Industry/TSTF Standard Technical Specification Change Traveler

Extend the Completion Time for inoperable isolation valve to a closed system to 72 hours

Industry/TSTF Standard Technical Specification Change Traveler

Industry/TSTF Standard Technical Specification Change Traveler

EXAMPLE B3.0.6-1

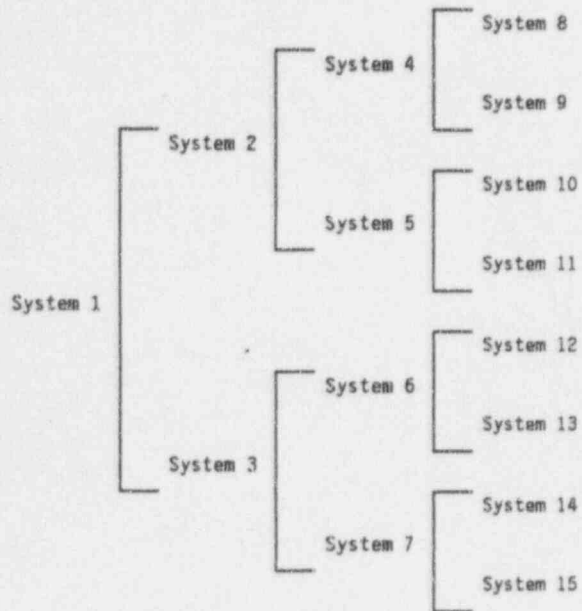
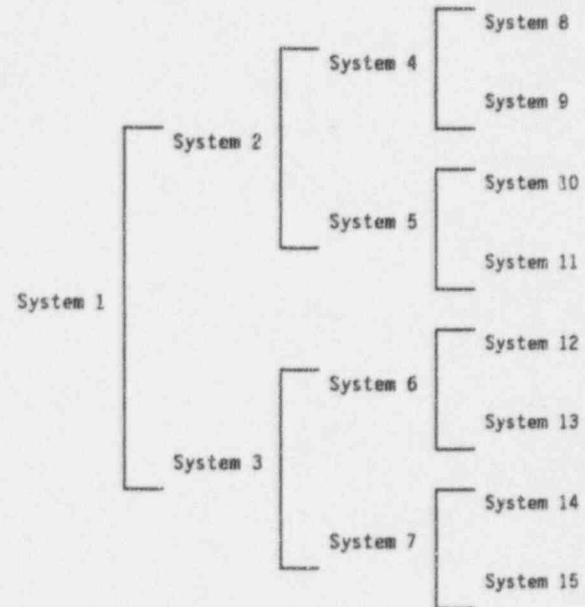
A brief example of the application of the Safety Function Determination Program is added in the Bases for LCO 3.0.6.

The application of LCO 3.0.6 is the cause of a great deal of confusion. The application can be explained using examples similar to those attached. This change to the Bases does not alter the technical content of LCO 3.0.6. The example is similar to one previously included in the Safety Function Determination Program.

If System 2 of Train A is inoperable, and System 5 of Train B is inoperable, a loss of safety function exists in supported System 5.
